**Subject: Addendum #1: Site Plan Update of Proposed Development at 800 Eagleson Road,
Ottawa - WSP Noise Impact Assessment File No: 181-02513-00**

Ottawa, Ontario
800 Eagleson Road
Egleson Apartments
Proposed Site Plan

PROPOSED SITE PLAN
SCALE: 1"=20'-0"

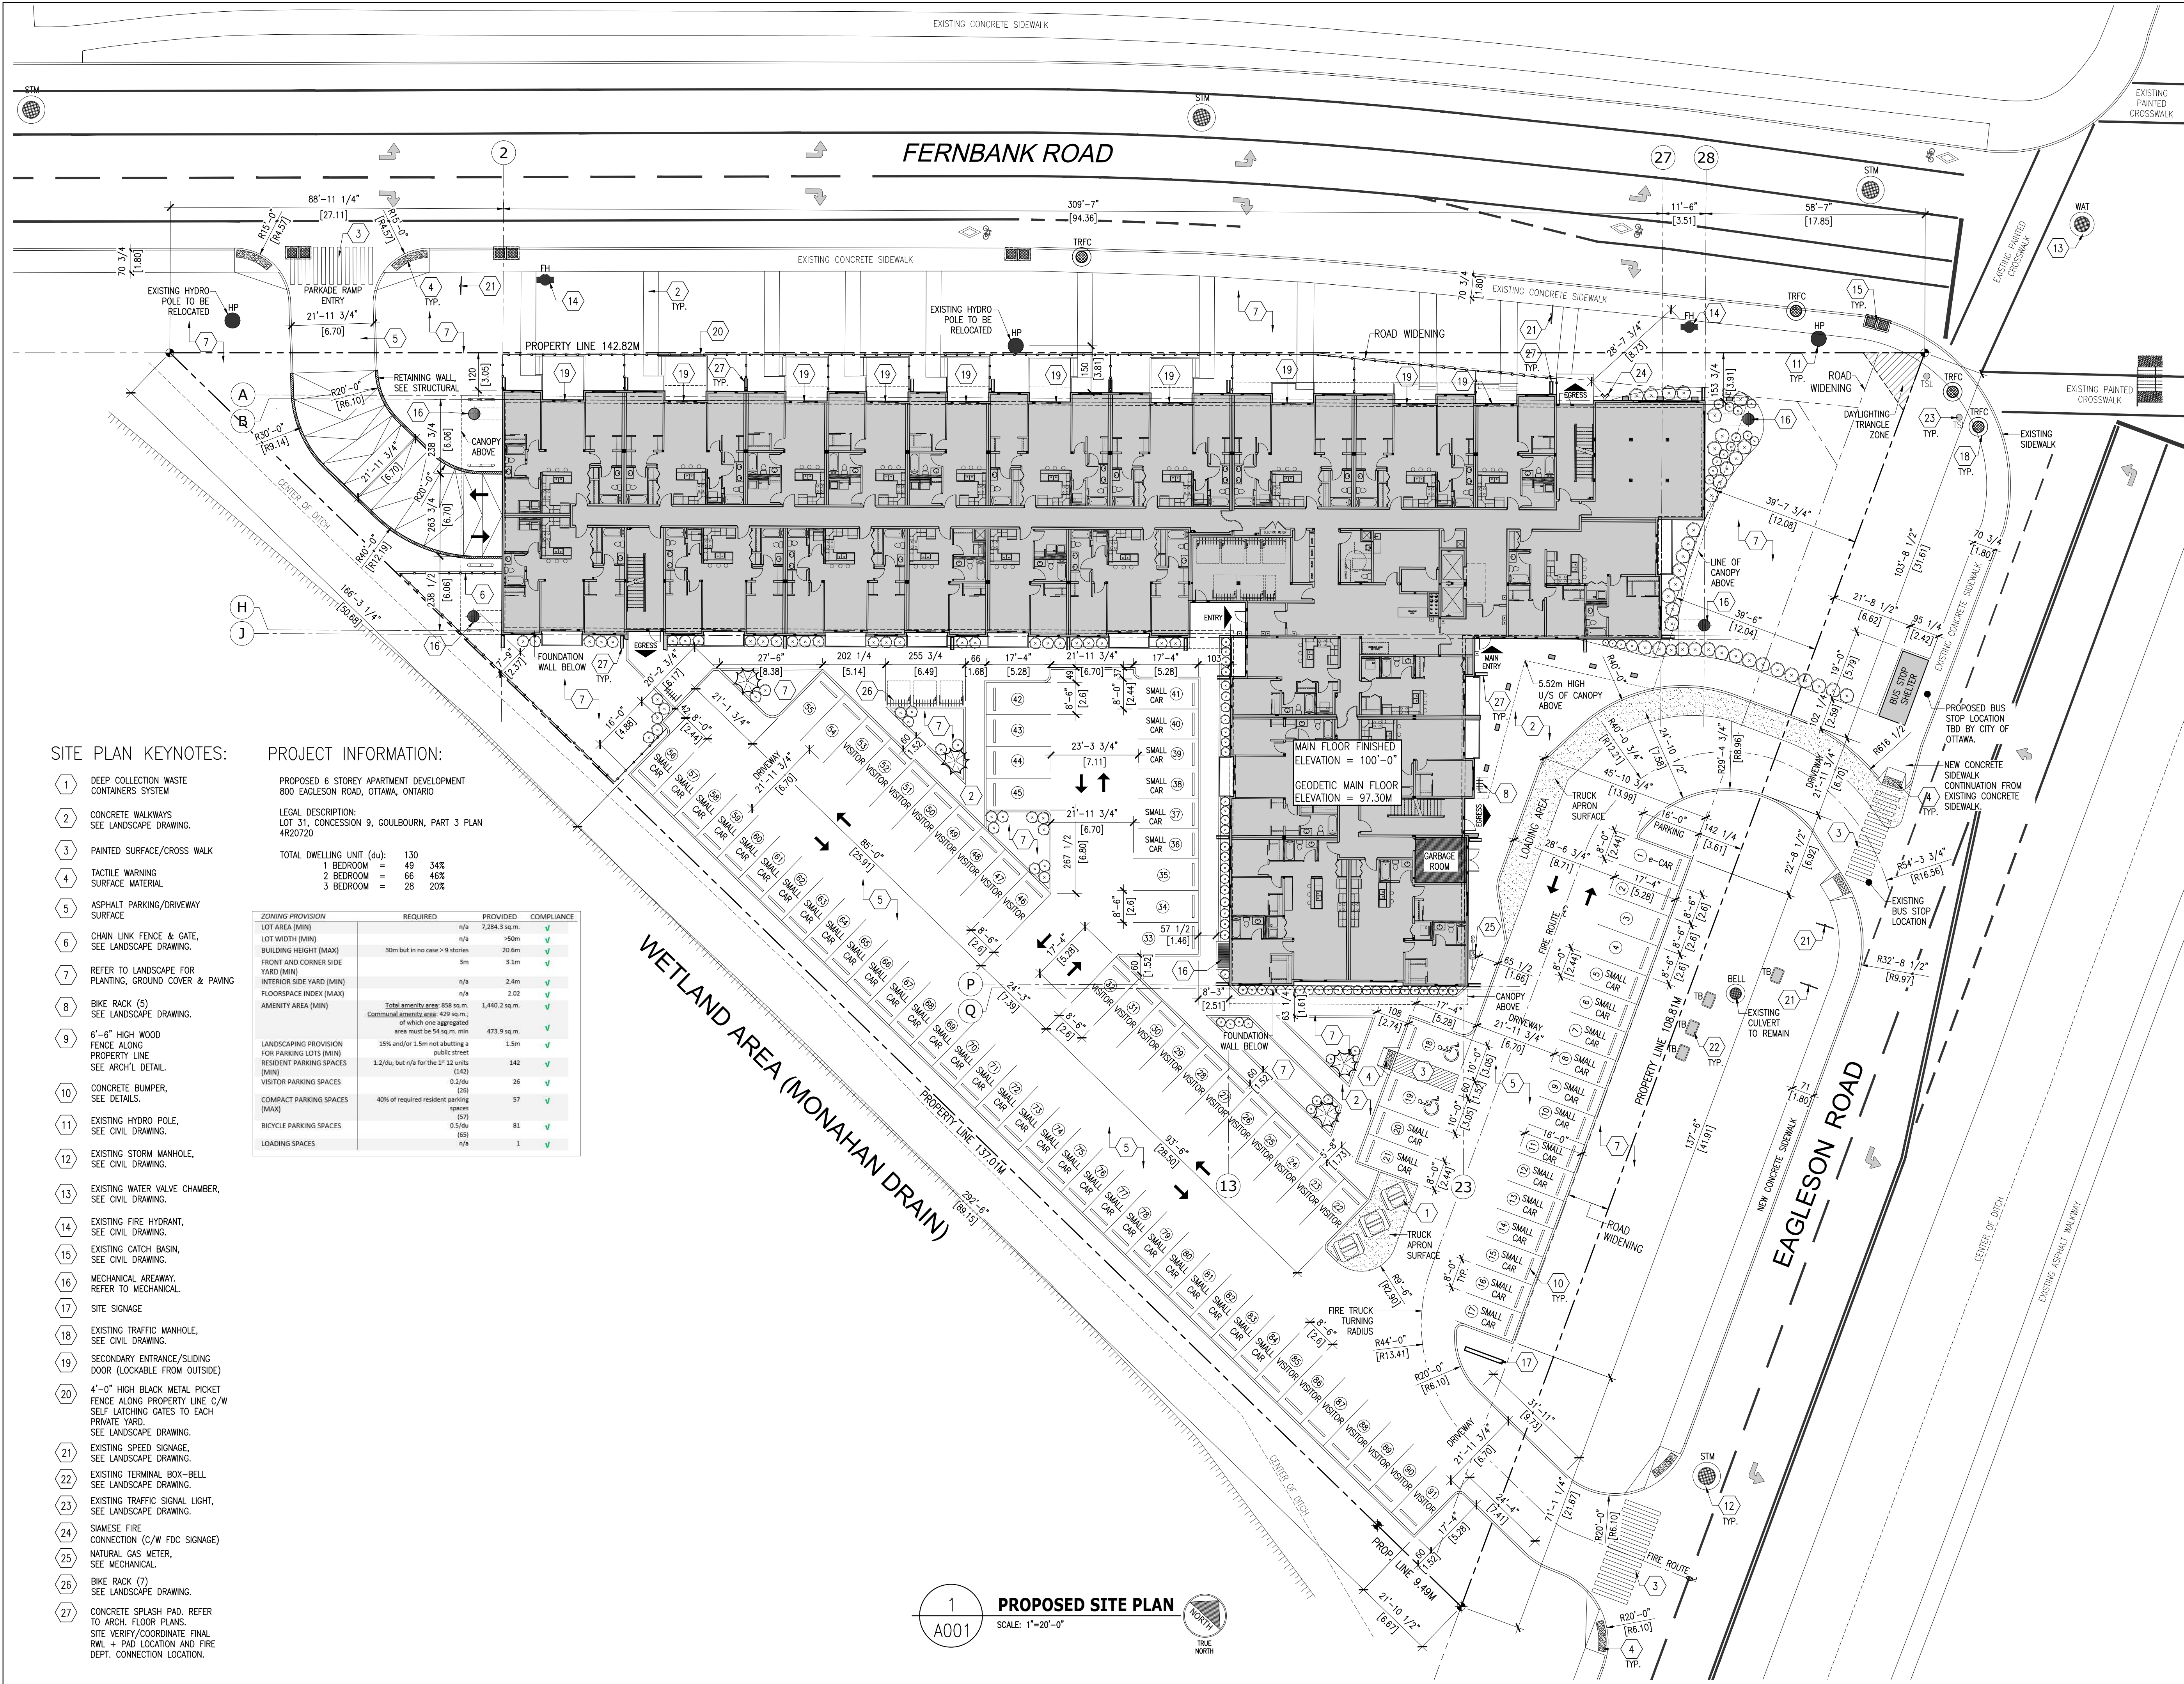
WSP's review indicated that the total number of dwelling units has changed to 130 from previously noted 143 units; this and other noted changes in the Site Plan are not anticipated to have impact on the noise control recommendations provided in the December 2018 NIA Report. Therefore, WSP concluded that the recommendations provided in the December 2018 NIA Report remain unchanged.
